Service Action

Code: 97DZ

Subject	Transmission Wiring Harness																												
Release Date	June 09, 2020																												
Affected Vehicles

Remove subframe end panel (if equipped):

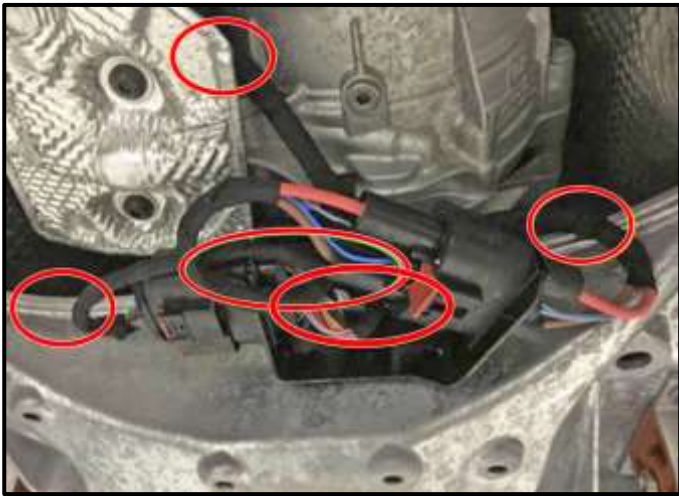
- Remove noise insulation.
- Remove fasteners <2, 3 and 4> and remove end panel <1>.

Inspect transmission wiring harness for damage:

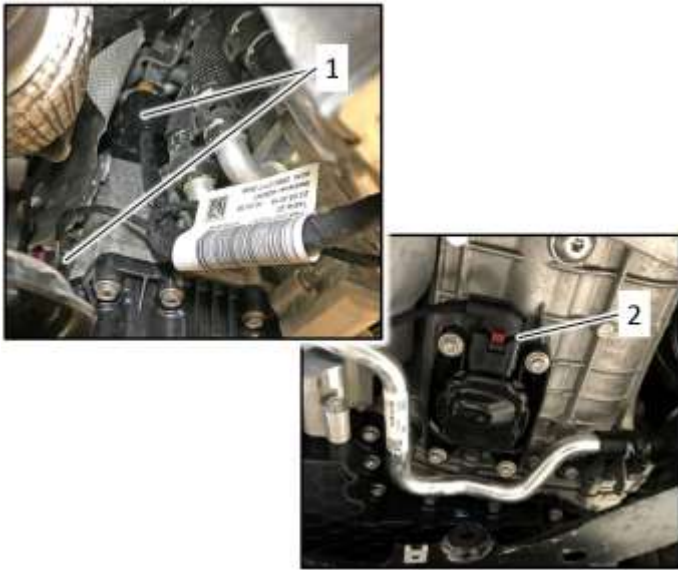
- Thoroughly inspect the transmission and body side wiring harness and routing near the areas shown.

- Pay very close attention to all areas making contact with any bracket or mount. Harness damage may be very subtle and even a light chaffing could lead to faults.
- Repair wiring as needed per the repair manual.
 - See ELSA Repair Manual: *Repair manual > Electrical System > Electrical Equipment General Information > 97 Wiring > Wiring Harness and Connector Repairs*
- Ensure the repairs are staggered as needed to:
 1. Avoid large bunches of repairs in the harness.
 2. Avoid a repair at a critical flex point, e.g. over the transmission cross brace.

Disconnect connectors:

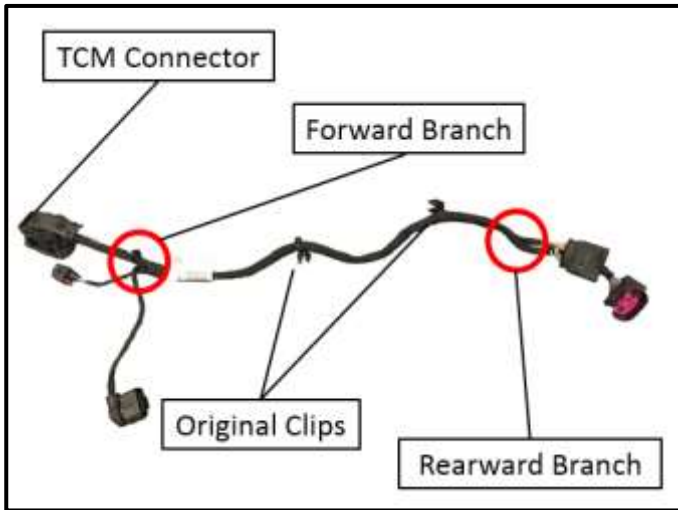
- Unlock and disconnect connectors <1> and <2> from transmission.
- Remove transmission wiring harness from vehicle.

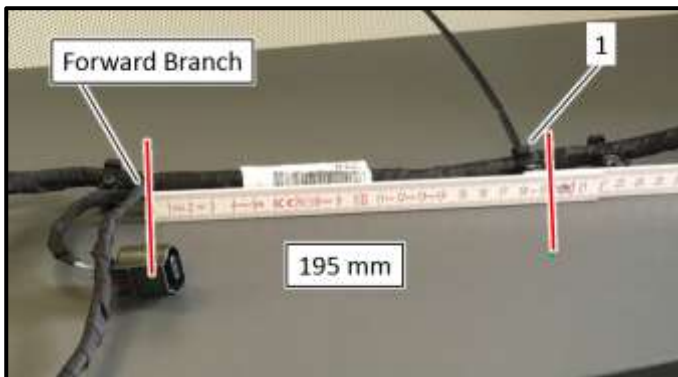
- Measure 195 mm from the forward branch on the wiring harness.
- Install new tie wrap clip <1>.

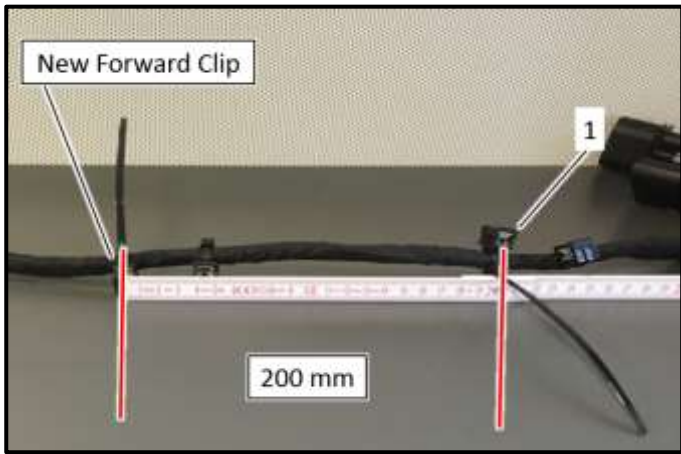
- The opening of the new clip should face the same direction as the original clip.

- Measure 200 mm from the new forward clip on the wiring harness.
- Install new tie wrap clip <1>.

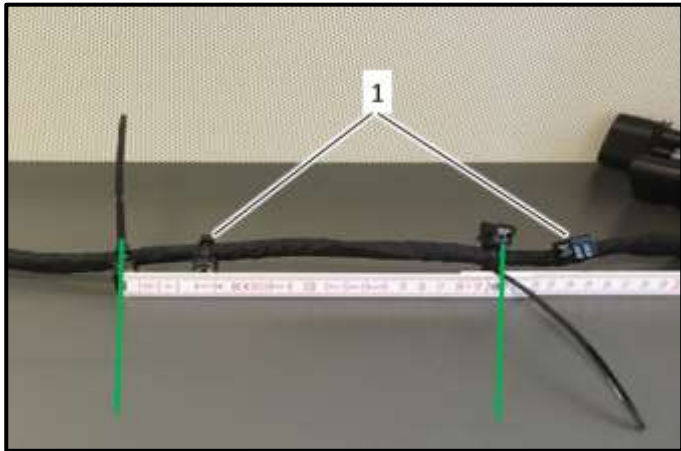
- The opening on the new clip should face the same direction as the original clip.

- Remove the old clips <1>.

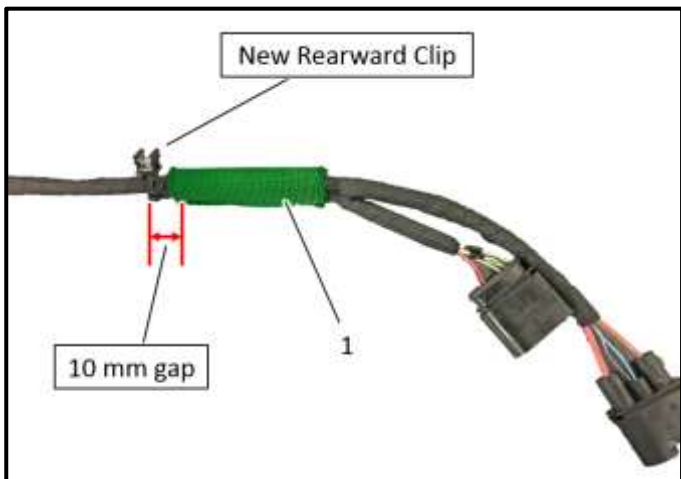
- Install the new protective sleeve <1> around the wiring harness.

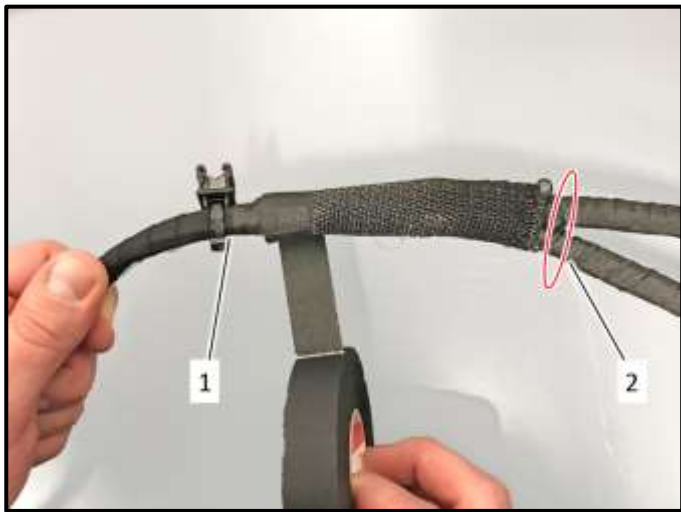
- Place the new protective sleeve <1> 10 mm from the new rearward clip.

- Wrap the protective sleeve with fabric tape.

- Wrap the tape from the new rear clip <1> up to the rear branch of the wiring harness <2>.

Deburr transmission cross brace:

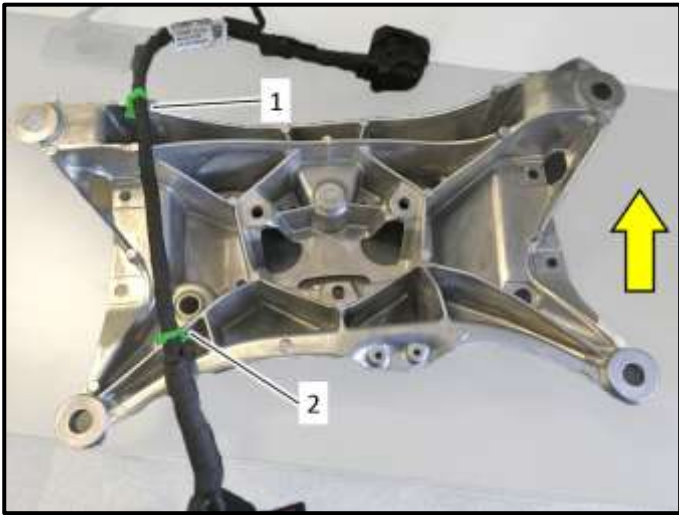
- Using a half-round file, lightly chamfer and smooth the rear edge of the transmission cross brace.

Transmission cross brace shown removed for clarity. It is not necessary to remove the cross brace.

- Avoid removing excessive amounts of material or deforming the cross brace.
- Ensure edges that will make contact with the transmission wiring harness are free of any burrs before proceeding.

Reinstall transmission wiring harness:

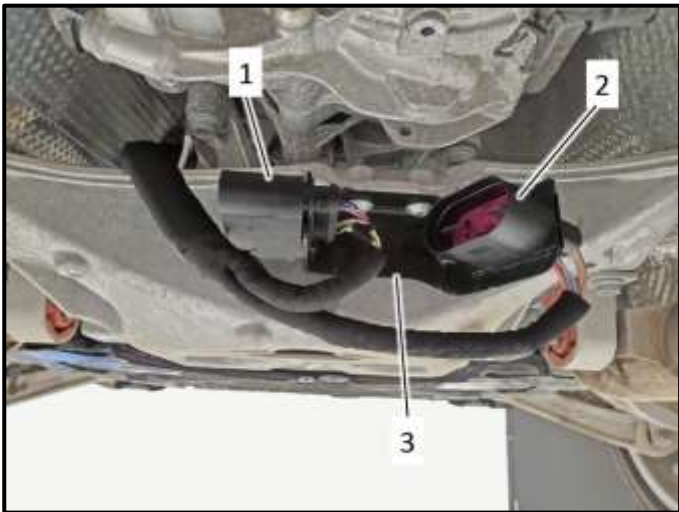
- Arrow denotes direction of vehicle travel.
- Route the transmission harness over the cross brace.
- Secure forward clip <1> and rearward clip <2> to the transmission cross brace.

Transmission cross brace shown removed for clarity. It is not necessary to remove the cross brace.

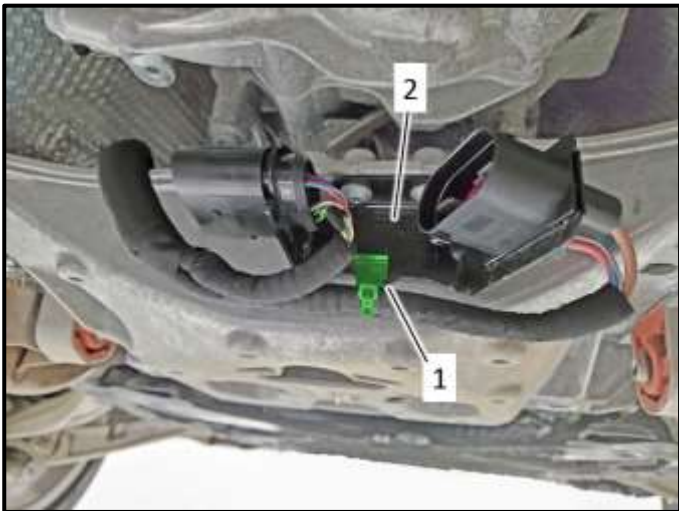
- Reinstall transmission harness connectors <1> and <2> into bracket <3>.
- Ensure the harness is routed as shown.

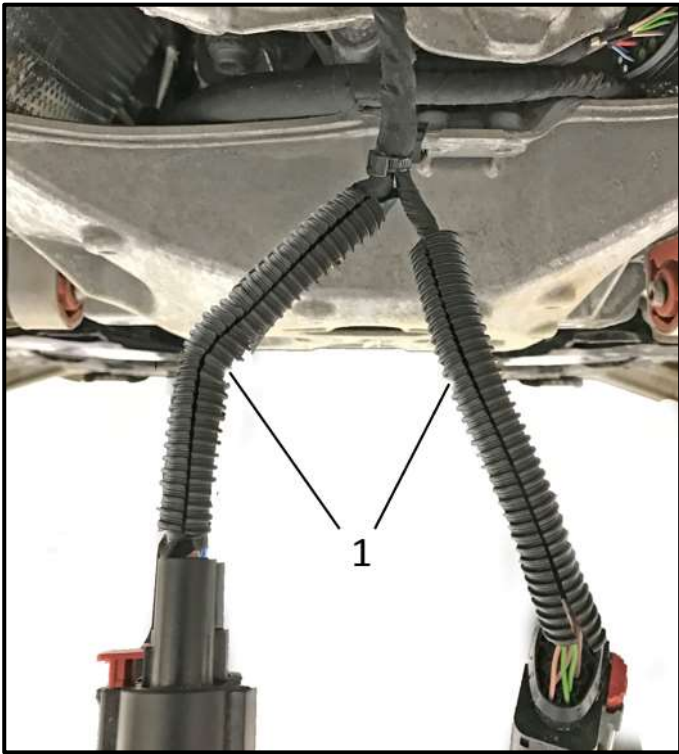
- Install new wiring harness clip <1> onto harness as shown and secure to connector bracket.

Install the clip at the central point of the connector bracket first, position the harness and then tighten the cable tie. This will aid in orientation of the harness.

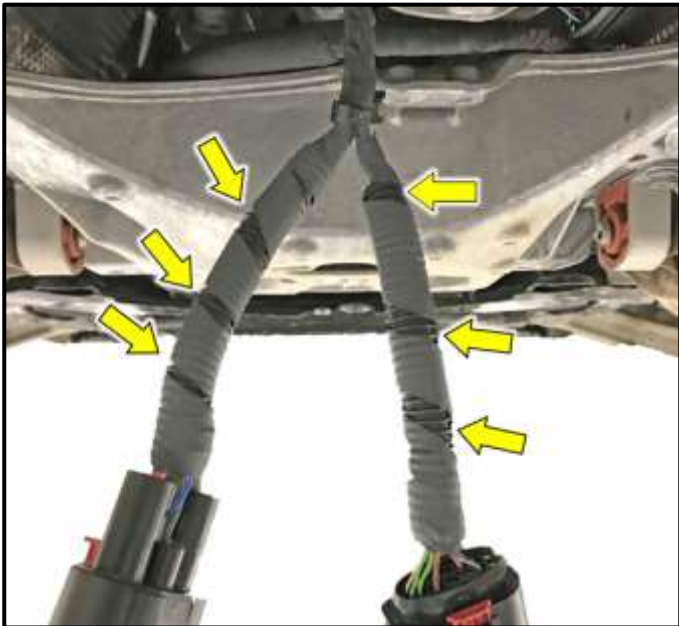
- Install 130 mm of corrugated tube <1> onto each body side wiring harness section as shown.

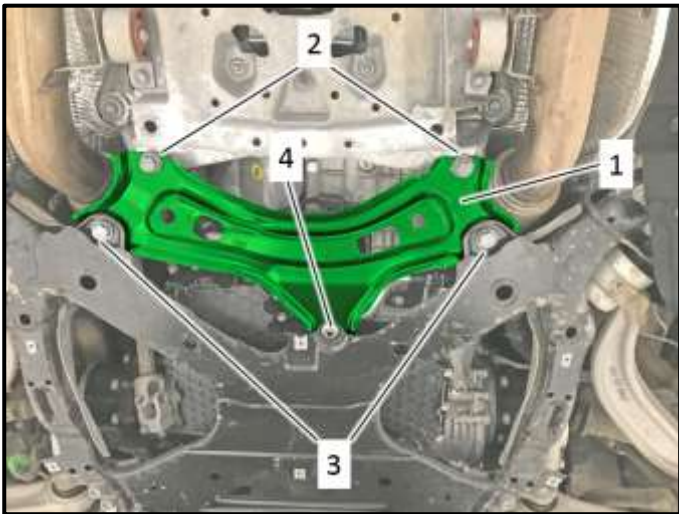
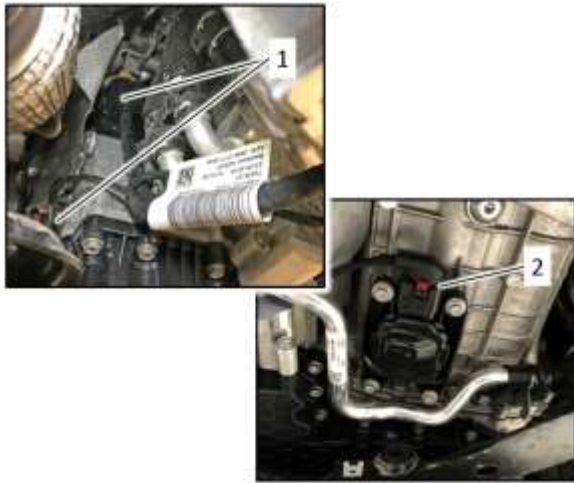
- Wrap corrugated tube with fabric tape.

- Ensure there is gap between the tape windings <arrows>.
- Ensure the corrugated tube is secured to the wiring harness with the fabric tape to prevent the harness from sliding inside the corrugated tube.

The gaps in the tape are necessary to allow water to flow out of the wiring harness.
